# Proposal for amendments to GRE/2012/44

# on Regulation No. 10 (Electromagnetic compatibility)

The text reproduced below was prepared by the expert from OICA to present comments on the working document GRE/2012/44 submitted by OICA, regarding the amendment of requirements in configuration "REESS charging mode coupled to power grid" for separate electrical component (ESA) and vehicles.

Figure 2

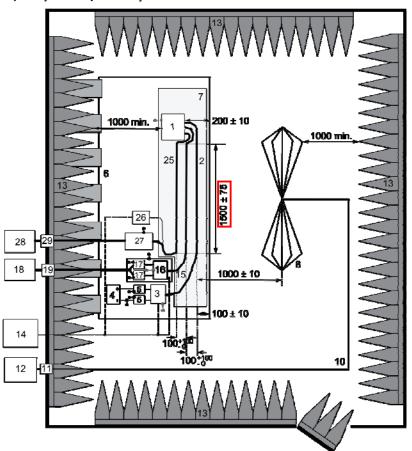
3.2.2 Unless otherwise specified the length of the LV harness and the HV harness parallel to the front edge of the ground plane shall be \(\frac{1700 \text{ mm} + 300/}{-0 \text{ mm}}\) 1.500 +/- 75 mm. The total length of the test harness including the connector shall be 1700 mm + 300/ -0 mm. The distance between the LV harness and the HV harness shall be 100 mm +100/-0mm.

Annex 7 and 9: It concerns the cable length of the high-voltage and low voltage test harness in the test-setups for ESA tests in annex 7 and 9. The active harness-length in front of the antenna has to be corrected to 1.500 +/- 75 mm (instead of 1.700 +300/-0mm) to be in line with current version of CISPR 25 and ISO 11452-2.

### Absorber chamber test

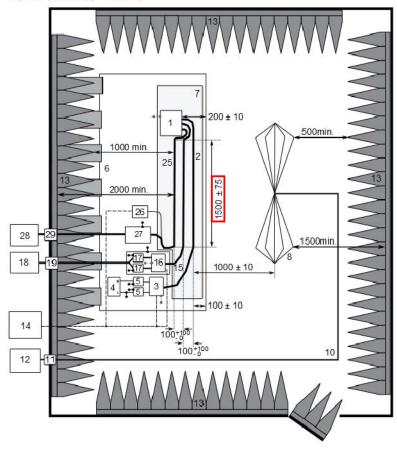
4.1.2.1.2 Unless otherwise specified the length of the LV harness and the HV harness parallel to the front edge of the ground plane shall be \(\frac{1700 \text{ mm} + 300/}{-0 \text{ mm}}\) 1.500 +/- 75 \text{ mm}\). The total length of the test harness including the connector shall be 1700 \text{ mm} + 300/ -0 \text{ mm}\). The distance between the LV harness and the HV harness shall be 100 \text{ mm} + 100/ -0 \text{ mm}\).
